**Re: Response to ADEQ Correspondence Dated November 24, 2014
Second Quarter 2014 Progress Report
Whirlpool Corporation
Fort Smith, Arkansas
EPA No. ARD042755389
AFIN No. 66-00048
CAO LIS 13-202**

ENVIRON International Corporation (ENVIRON), on behalf of Whirlpool Corporation, is submitting this response to comments in your November 24, 2014, comment letter on ENVIRON's response dated October 22, 2014, regarding the Second Quarter 2014 Progress Report.

Appendix C.3: Soil Moisture Profile for Residential Building (Slab on Grade) Whirlpool, Fort Smith, Arkansas

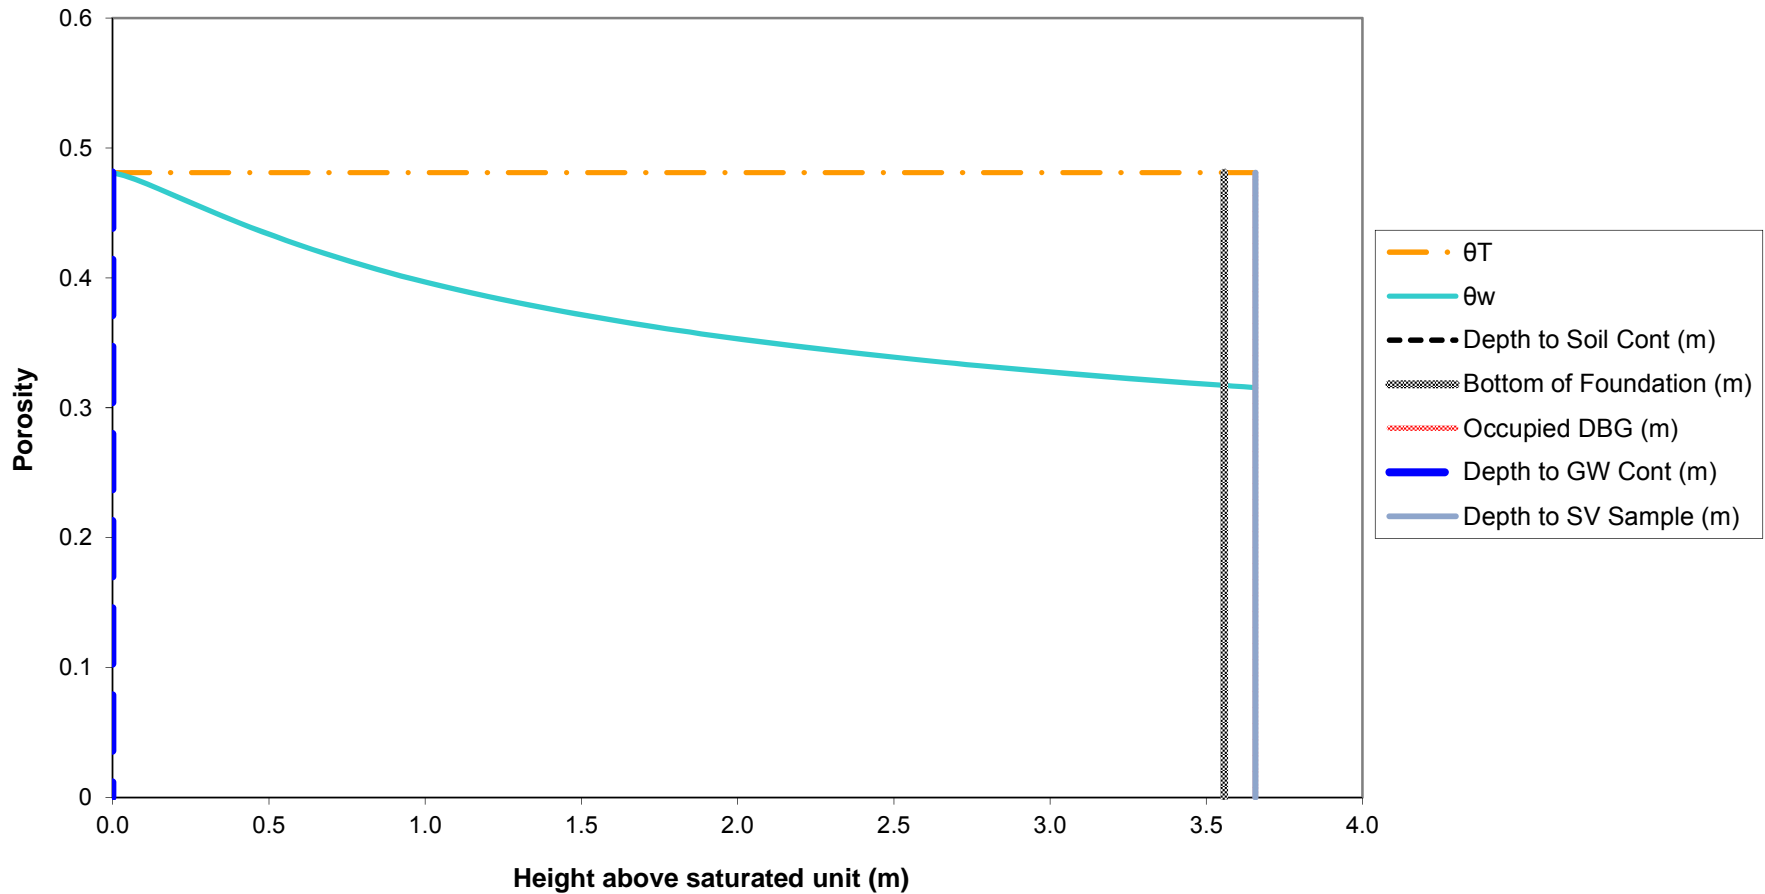
The calculation of potential vapor intrusion risk estimates from groundwater is performed as discussed in Section 3.3.1 of the Human Health Risk Assessment that was included as Appendix A to the *Revised Risk Management Plan* (2013). Specifically, the indoor air concentration resulting from groundwater vapor intrusion into a building are estimates using the attenuation factor (α) described by Johnson and Ettinger (1991). The α is derived in Johnson and Ettinger's 1991 journal article and the total effective diffusion (D_{eff}^T) input is calculated using a soil-water profile in the Vadose Zone estimated using the van Genuchten soil-water retention equation with default water retention parameters appropriate for silty clay (USEPA 2004a).

The soil-water profile in the vadose zone is estimated using the van Genuchten soil-water retention equation with default water retention parameters appropriate for silt clay, as discussed in Appendix A, Section 3.3.1 of the ADEQ-approved Revised Risk Management Plan, which was used as the basis for the ADEQ Remedial Action Decision.
